Delmore Expert Panel

DELMORE FTAA-2512-1164: INVITATION TO COMMENT: AVJ HOBSONVILLE PTY LTD

Figure 1: Plan showing location of Grand Drive Extension

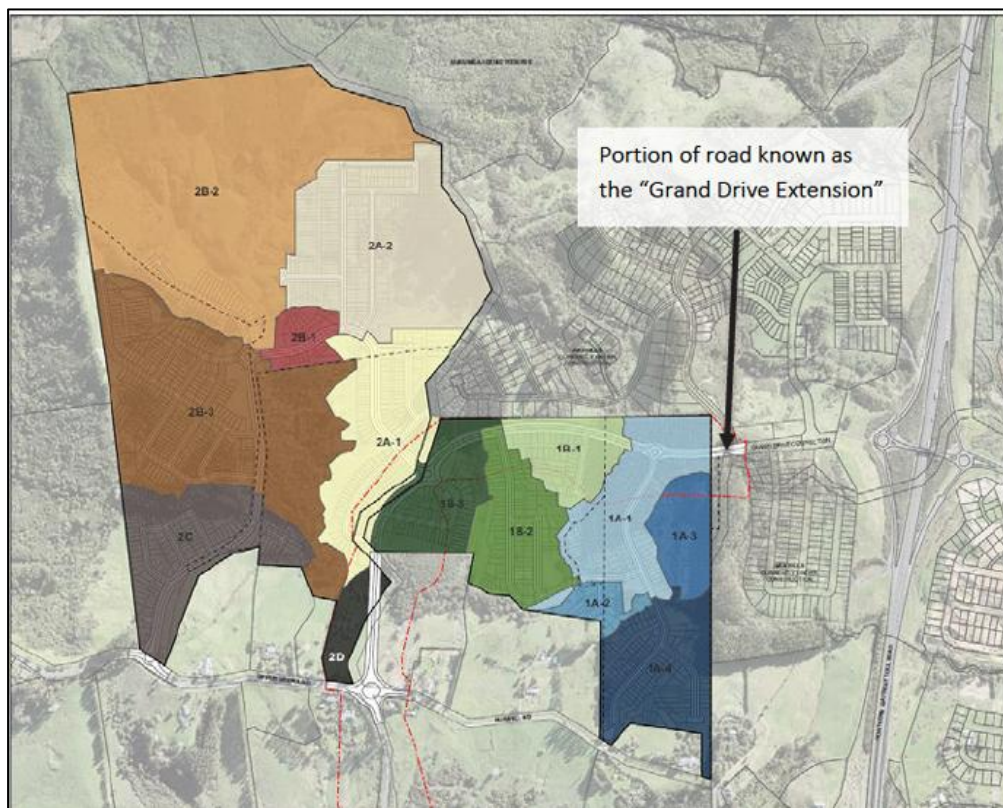
- 3.7 Vineway has set out on page 42 of its AEE that access to the Delmore development for Stage 1 will be via Grand Drive.
- 3.8 There is approximately 120m between the current termination of Grand Drive and the Delmore site's eastern boundary. For the road network within the Delmore site to connect to Grand Drive, the Grand Drive Extension needs to be constructed.

- 3.9 Fundamentally, Vineway and AVJ disagree with *who* should provide what Vineway has termed the "Grand Drive Extension".
- 3.10 By way of further context, AVJ is open to working with Vineway on a potential agreement covering interface / infrastructure, including the road, but at the time of this submission:

- 5.2 AVJ has no obligation to deliver the Grand Drive Extension under the resource consent, and in any event, its obligations under the existing resource consent have already been met by vesting the Grand Drive Extension as a paper road.

- (a) Vineway is correct that AVJ was required to vest the land for the Grand Drive extension by April 2028. AVJ has done so and the land has vested. Vesting, in this case, did not require construction of a carriageway.

Figure 4A: Orange arrows marking lack of formed connections to the boundary at 6-8 Te Rata Boulevard and 2 Meteoriti Crescent in Paerata

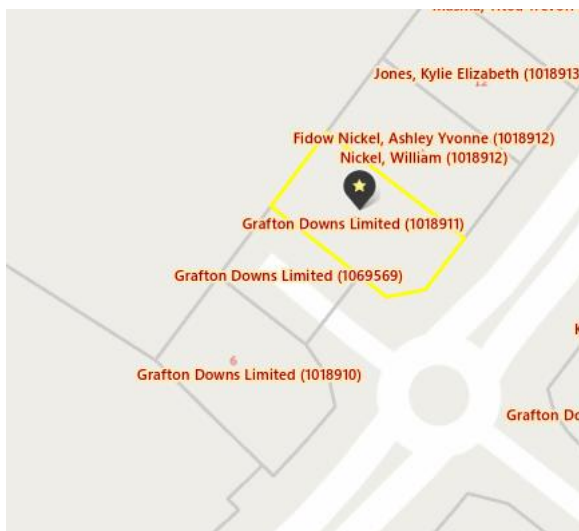
- 5.7 AVJ has been advised that an example of neighbouring developments where connectivity is being precluded by the way in which development is unfolding can be seen at the boundary between 6-8 Te Rata Boulevard and 2 Meteoriti Crescent in Paerata. The road is not physically built to the boundary, but more importantly the land parcel connecting the road has **not** been vested in Auckland Transport, it remains privately owned, see figures 4A and 4B below. This outcome must be avoided.

Figure 4 - Cross section highlighting the level difference between existing streams, the proposed NOR 6 arterial road, and the natural ground level at the northern site boundary.

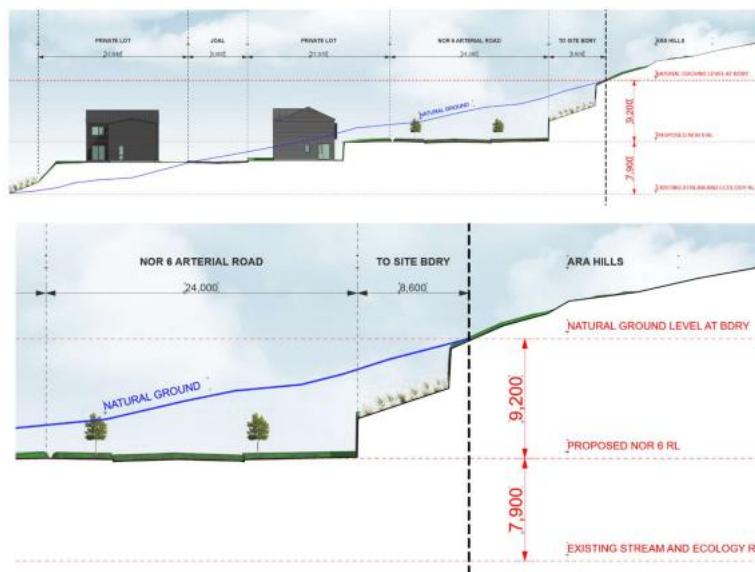
If a stub road was to be provided between the NOR 6 arterial road and the northern site boundary, a retaining wall of approximately 8.5m would be required along the common boundary with approximately 15m-20m of cut required by the Ara Hills development to enable connection.

6.11 AVJ's masterplan shows earth worked levels lower than is depicted in Vineway's Appendix 9.2 listed above. It is also noted that the ground slopes considerably in this location and by repositioning the connecting stub road slightly, the levels would match much better and the resulting earthworks and gradients could be substantially reduced.
